Warwick District Council

B4113 Stoneleigh Road Green Overbridge

**Schedule 17 Plans and Specifications Written
Statement for Information**

HS2 Consents ID: WAC.PS.10039

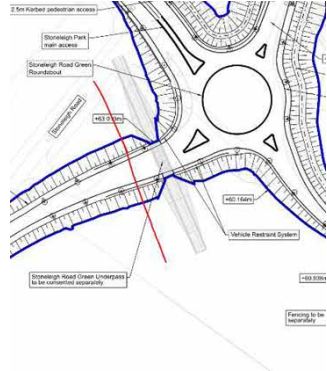
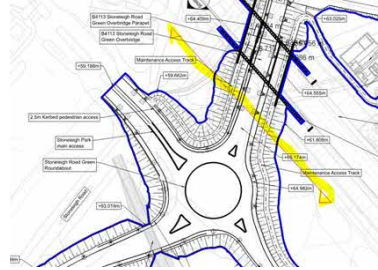
<p>What is this, where is going, is it required? As illustrated can't access it.</p> 	<p>The GA (Drawing No.: 1MC08-BBV_MSD-PL-DGA-NS01_NL03-138602) has been updated to show the PROW and track correctly. The ramp is for pedestrian access up the embankment onto the Stoneleigh Road footway, to facilitate the PROW diversion.</p>

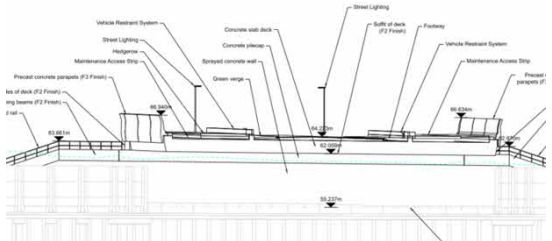
WDC/WCC Comment	Applicant Response
<p>Earthworks here poorly illustrated</p> 	<p>The general arrangement drawing (Drawing no.: 1MC08-BBV_MSD-PL-DGA-NS01_NL03-138602) has now been updated to correctly represent the earthworks in this area.</p> 
<p>What are some of these lines / the gap between earthworks and footpath ? Labelling required or remove. If a VRS needs to be labelled. Could be shown in a different colour?</p> 	<p>The GA (Drawing no.: 1MC08-BBV_MSD-PL-DGA-NS01_NL03-138602) has now been updated, there is no longer a gap between the earthworks and footpath. The VRS is now shown in red.</p> 
<p>Why is this so wide? Clarification in note or within WS required as to what this is.</p> 	<p>This wide verge accommodates a 3m wide hedge which is a key ecological component of the scheme, plus utilities and lighting columns, the shown verge width is therefore required.</p>
<p>Can we please reduce some of the grey within site boundary to improve drawing legibility, or use a lighter grey? and then significantly soften the concrete piles so far less prominent in the drawing, and the road can be read clearly. Plan would also benefit from a label to the grass verges/additional deck plan.</p>	<p>GA (Drawing no.: 1MC08-BBV_MSD-PL-DGA-NS01_NL03-138602) has now been updated, the grey within the site boundary has been reduced and concrete piles softened. An additional deck plan has also been produced.</p>

<p>Break in footpath is that correct or have earthworks been drawn too wide here.</p> 	<p>There is a wide verge here to accommodate features described in a previous comment, plus maintenance access strip, there is no break in the verge – the earthworks display has been amended.</p>
<p>More labelling required. VRS including type. No transition panels to ends?</p> 	<p>The elevation (Drawing no.: 1MC08-BBV_MSD-PL-DEL-NS01_NL03-138604) has been updated, transition panels and VRS are now shown. The VRS details are provided in Section 3.2.</p> 
<p>public footpath, label in the elevation A</p> 	<p>The elevation (Drawing no.: 1MC08-BBV_MSD-PL-DEL-NS01_NL03-138604) has been updated, the PROW is now labelled.</p>

WDC/WCC Comment	Applicant Response
<p>Clearer cut through section needed or reduce some of these lines, very unclear what this is showing, or add a label.</p> 	<p>The elevation (Drawing no.: 1MC08-BBV_MSD-PL-DEL-NS01_NL03-138604) has been updated to show the design more clearly.</p> 
<p>VRS? Label required, additional info re height and type would be beneficial within Written statement</p> 	<p>The elevation (Drawing no.: 1MC08-BBV_MSD-PL-DEL-NS01_NL03-138604) has been updated and VRS is labelled. Height and material details of VRS provided in the Written Statement.</p> 
<p>Label. No lighting bollards / columns shown in any elevations, can these be added as they form part of the proposals. Include spot heights.</p> 	<p>The section (Drawing no.: 1MC08-BBV_MSD-PL-DSE-NS01_NL03-138605) has been updated to show light columns. Light bollards are no longer proposed.</p> 
<p>Sections through bridge need to show and label the green verge, the MAT, and pedestrian pavement. May be better taking section perpendicular to road rather than track.</p> 	<p>The section (Drawing no.: 1MC08-BBV_MSD-PL-DSE-NS01_NL03-138605) has been updated to address comment, verge, MAS and footway now labelled.</p>

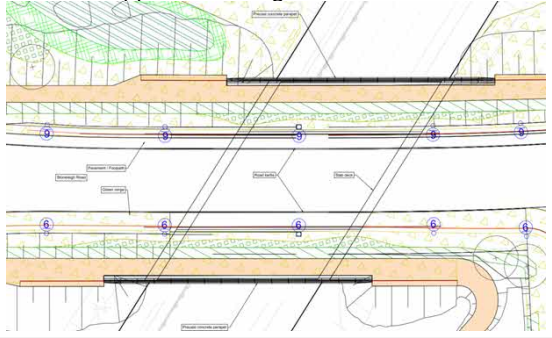
WDC/WCC Comment	Applicant Response
<p>Hatching alignment across the drawing is poor – though indicative it does still need to be somewhat accurate. Avoid hatching over MAT and footpaths.</p> 	<p>The LEMP (Drawing no.: 1MC08-BBV_MSD-PL-DGA-NS01_NL03-138603) is still being refined. The final landscape design scheme, incorporating these initial comments and showing all landscape mitigation including planting and seeding designs and mixes, will be provided for final comment at the Bringing into Use application stage.</p>
<p>Despite being a green overbridge the illustration of this and the green verges are not clear on the drawing. This is also raised in Landscape Officer feedback.</p>	<p>The LEMP (Drawing no.: 1MC08-BBV_MSD-PL-DGA-NS01_NL03-138603) is still being refined. The final landscape design scheme, incorporating these initial comments and showing all landscape mitigation including planting and seeding designs and mixes, will be provided at the Bringing into Use application stage.</p>

<p>Lighting needs to be shown on landscape plan as per the GA.</p>	<p>The LEMP (Drawing no.: 1MC08-BBV_MSD-PL-DGA-NS01_NL03-138603) does not show lighting as it is still being refined. The final landscape design scheme, incorporating these initial comments and showing all landscape mitigation including planting and seeding designs and mixes, will be provided for final comment at the Bringing into Use application stage.</p>
<p>Additional drawing of deck plan should be submitted (landscape and GA)</p>	<p>An additional deck plan (Drawing no.: 1MC08-BBV_MSD-PL-DGA-NS01_NL03-138607) has been produced.</p>
<p>The Overbridge structure will comprise a single span concrete slab deck spanning approximately 30m, with an overall carriageway width of 11.2m. The Written Statement references two 8m wide greenways either side however this does not correlate with what I am measuring on the plan. That said, the plan is difficult to read and it would be helpful to submit an additional deck plan so the layout of the overbridge can be considered clearly (both GA landscape).</p>	<p>An additional deck plan (Drawing no.: 1MC08-BBV_MSD-PL-DGA-NS01_NL03-138607) has been produced and shows the bridge deck and greenways in more detail.</p>

<p>The elevation through the overbridge also lacks detail, and the arrangement of MAT/verge/pedestrian path/road/VRS is very unclear or not shown at all. This drawing needs to be improved to show proposals</p>	<p>Labelling has been added to the section (Drawing no.: 1MC08-BBV_MSD-PL-DSE-NS01_NL03-138605) to clarify the features shown including MAS, verge, footway, VRS.</p>
